Docket Nos: 50-398/391

SUBJECT: REQUEST FOR ADDITIONAL INFORMATION CONCERNING THE WATTS BAR
NUCLEAR PLANT, UNITS 1 AND 2

REQUEST FOR ADDITIONAL INFORMATION

Figure 1: - Accumulated Wear of Big Bore Diameter as a Function of Time for "Critical" Bearings.

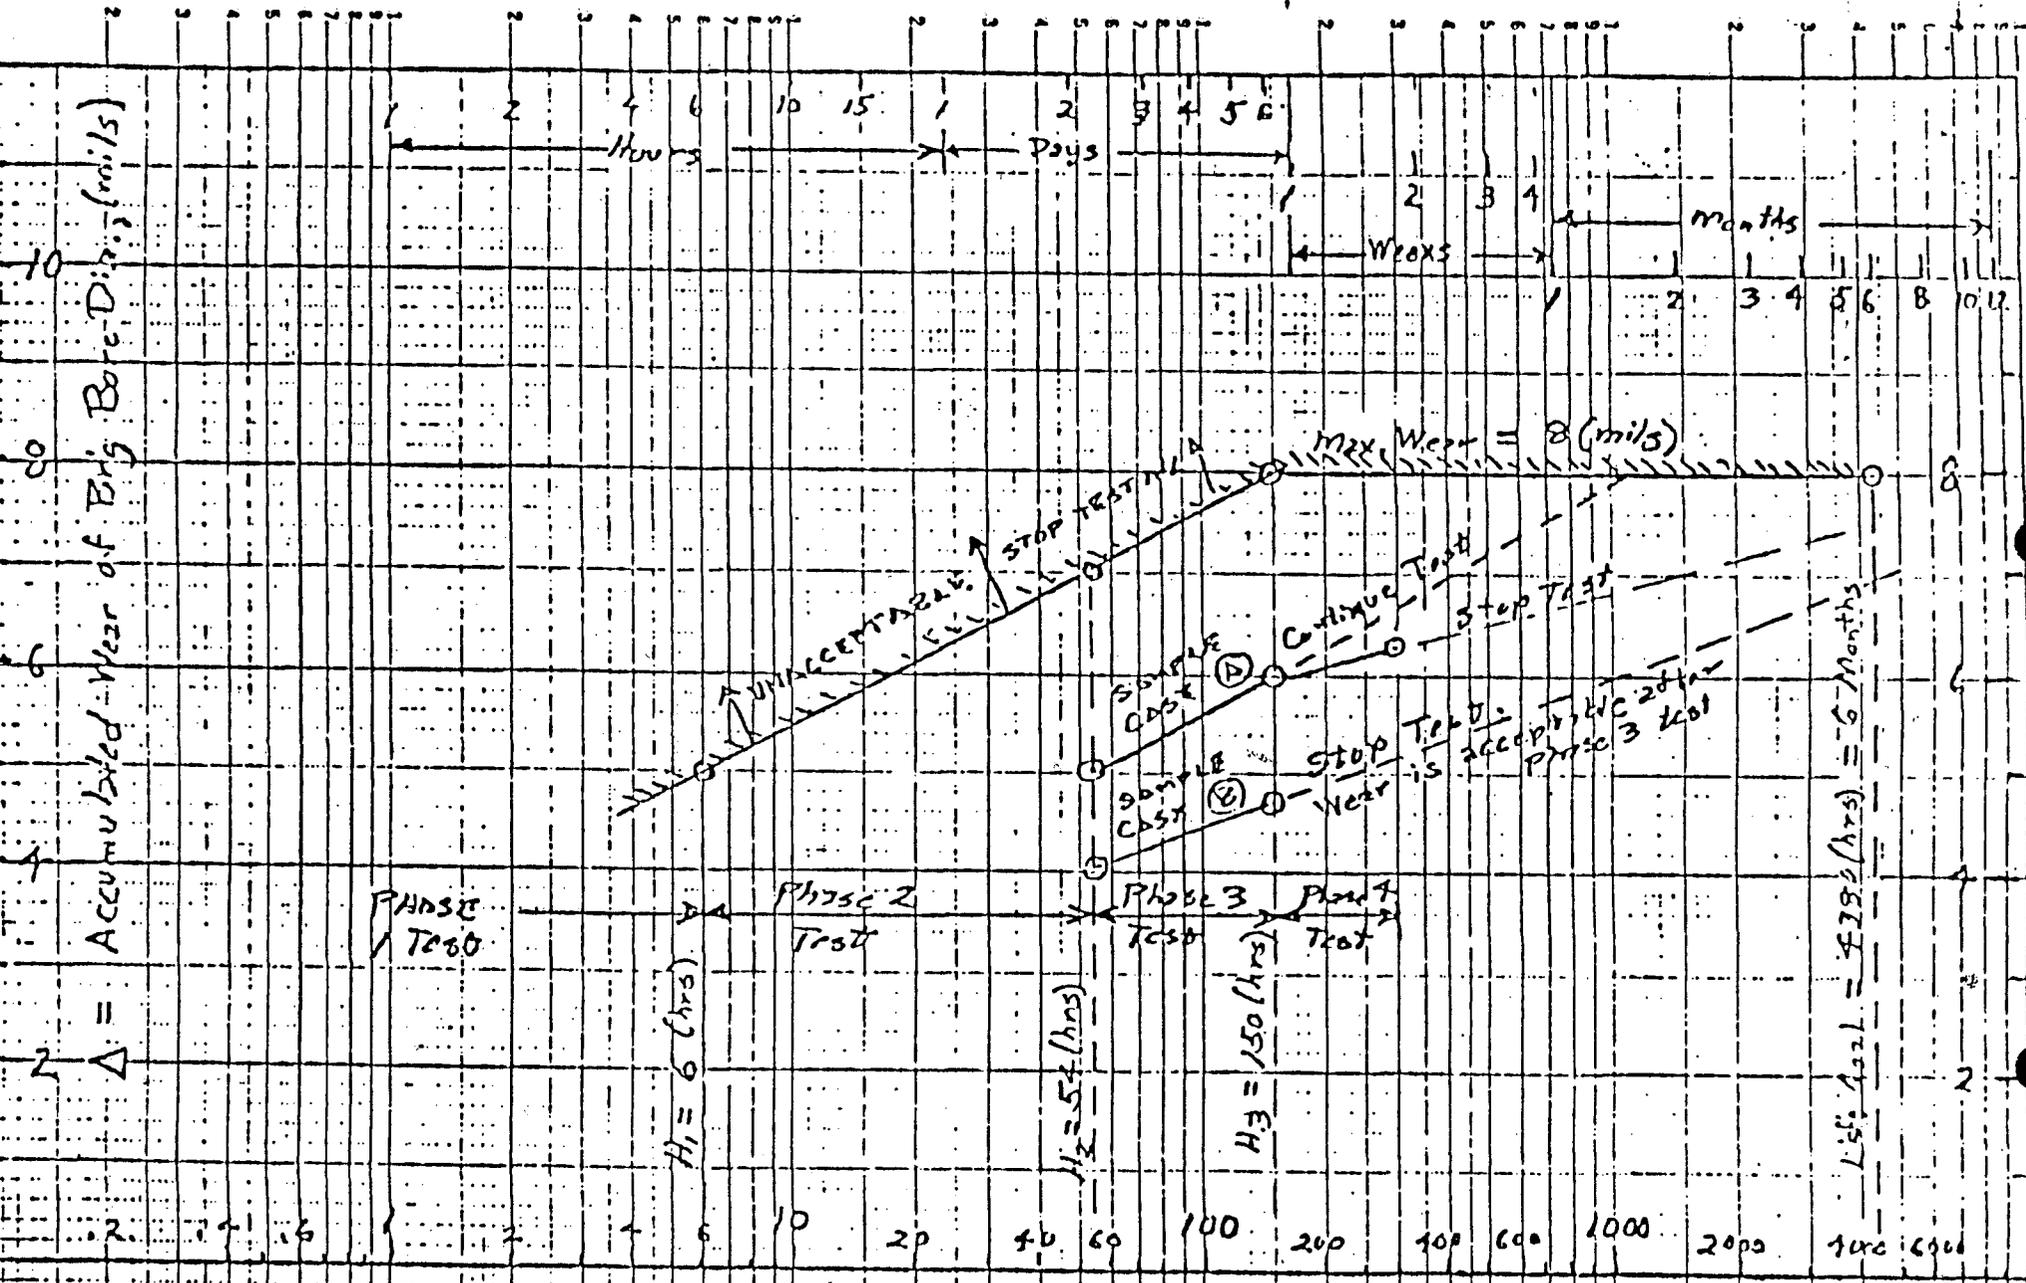
Plot the values of accumulated wear versus time (H) for each bearing after Phase 2 and Phase 3 tests, namely.

Straight lines are then drawn through the plotted values of wear and extended to the right (See example Figure 1). If the extension intercepts the maximum acceptable value of wear (8 mils) at a value H less than the life goal for this pump, additional testing should be performed. If the intercept of the line with wear of 8 mils exceeds the life goal for this pump, no additional testing is required and bearing wear is acceptable. If additional testing is deemed necessary it should be done in a similar manner to that performed during Phase 3 with similar acceptance criteria and decision process. It is expected that such additional testing will either show a stable pump operation with no increase in bearing wear or increased bearing wear with unacceptable results.
